Subject: Reactor Building Polar Crane Load Test

SAFETY EVALUATION BY THE  
OFFICE OF NUCLEAR REACTOR REGULATION  
THREE MILE ISLAND PROGRAM OFFICE  
FACILITY OPERATING LICENSE NO. DPR-73  
GPU NUCLEAR CORPORATION, ET AL.  
THREE MILE ISLAND NUCLEAR STATION, UNIT 2, (TMI-2)  
DOCKET NO. 50-320  
REFURBISHMENT OF THE REACTOR BUILDING POLAR CRANE,  
LOAD TEST, AND RECERTIFICATION FOR USE

THREE MILE ISLAND PROGRAM OFFICE  
SAFETY REVIEW OF THE  
REACTOR BUILDING POLAR CRANE LOAD TEST

**FIGURE 8.1**  
**POLAR CRANE LOAD TEST ASSEMBLY**

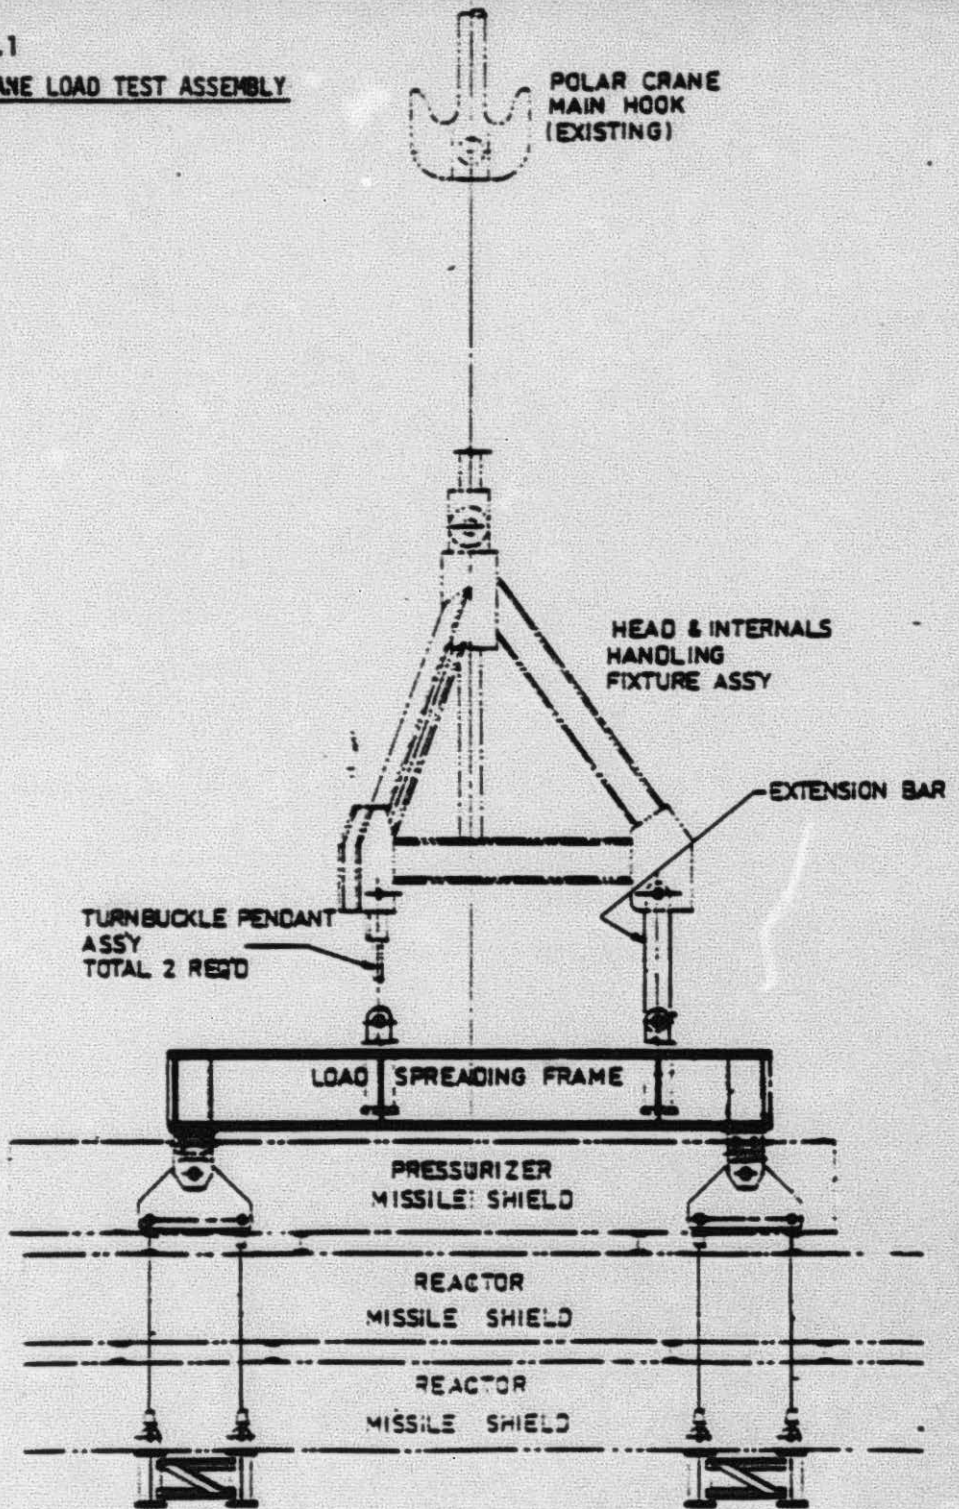
Four wire rope slings are required for each missile shield, each being attached at the lifting lugs of the shield at one end and attached to and a single plate at the other (see Figure 8.1). Because the missile shield structure is a rigid body and the possibility does exist that the slings will not be exactly the same length, the missile shield lift is categorized as indeterminant from the standpoint of stress analysis. Therefore, in our evaluation of the potential load on each sling, only two of the four

FIGURE 10.4

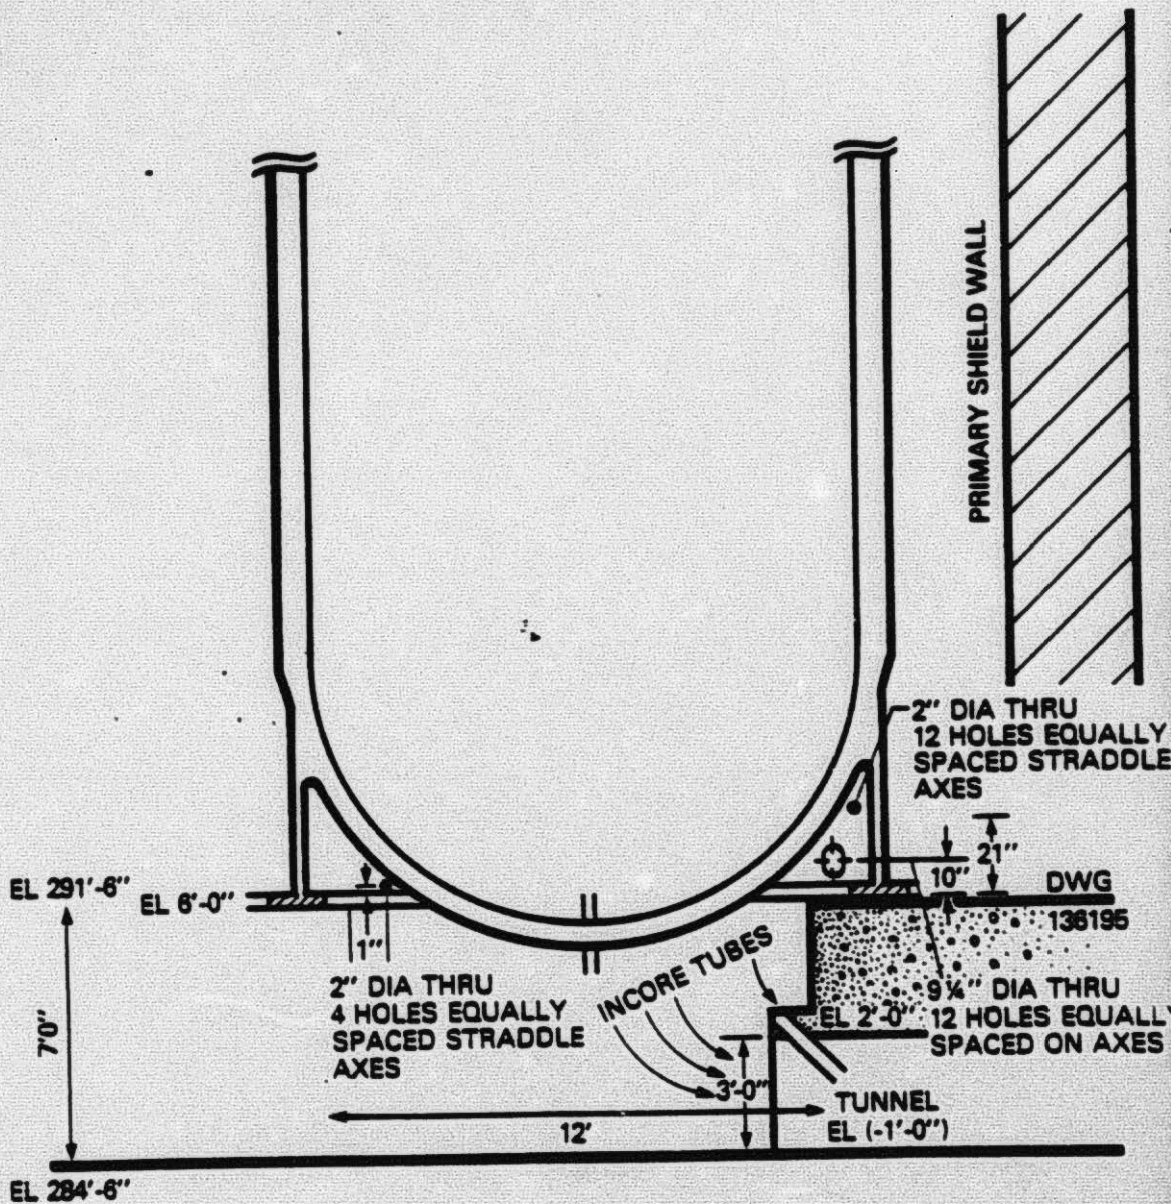
We do not consider the severing of the in-core instrument tubes which penetrate the lower reactor vessel head to be a credible event for a number of reasons. First, a significant amount of the kinetic energy in the missile shield would be dissipated in the deformation of the service structure (see Figure 10.1). Second, the missile shield would have to fragment into pieces which would fit within the physical constraints of the reactor vessel and surrounding concrete structure, an annulus of slightly less than 2 feet of maximum clearance (see Figure 10.2). The fragmented pieces would have to clear the four 28 inch diameter inlet pipes, two 36 inch diameter outlet pipes, and two 14 inch core flood tank pipes which penetrate the reactor vessel (see Figure 10.3). Having cleared the vessel piping, a piece of missile shield no larger than about 9 inches in maximum dimension would have to strike the concrete pad supporting the reactor vessel, bounce at a 90° angle and pass through one of the 9-1/4 inch diameter holes in the reactor vessel support skirt, and strike an in-core instrument tube with enough energy to fail 0.22 inch thick tubing (see Figure 10.4). We consider such an event to be incredible.
